DATE ~~R~~ Mar. 6/03**V2500-A5 PROPULSION SYSTEMS SERVICE BULLETIN**

This document transmits Revision 1 to Service Bulletin EV2500-73-0128 and the Initial Issue of the Supplement

ENGINE FUEL AND CONTROL – FUEL SYSTEM AIR TUBES – INTRODUCTION OF HEAT RESISTANT CLIPS FOR THE PB SENSE-LINE TUBE ASSEMBLY AND THE DELETION OF A CLIP AT CP6094

Clip Point CP6094 Before and After Alteration
Figure 1

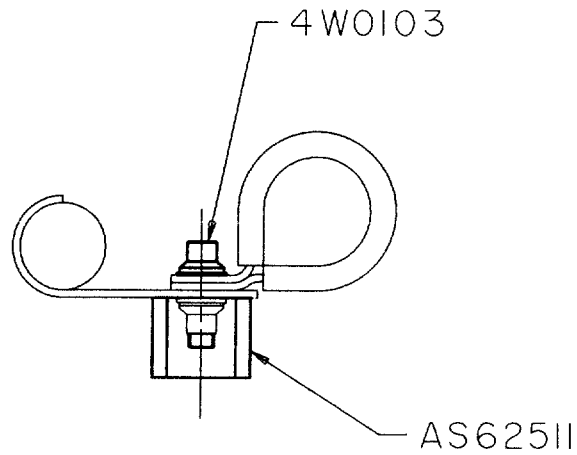
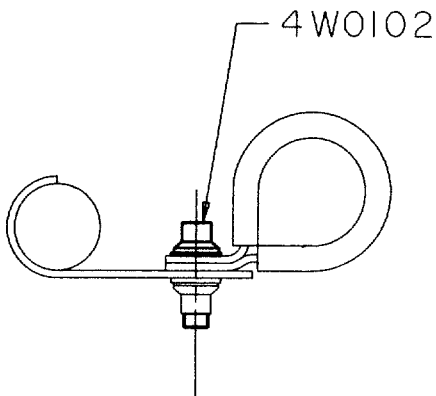
Also, insufficient clearance can exist between the cushion on a clip at CP6094 limb connector NP4009VC and the adjacent EEc core harness.

To increase the clearance, the clip (AS62511, Figure 1) that supports the EEC core-harness limb to the bifurcation panel connector NM4008VC at clip point CP6094 has been deleted.
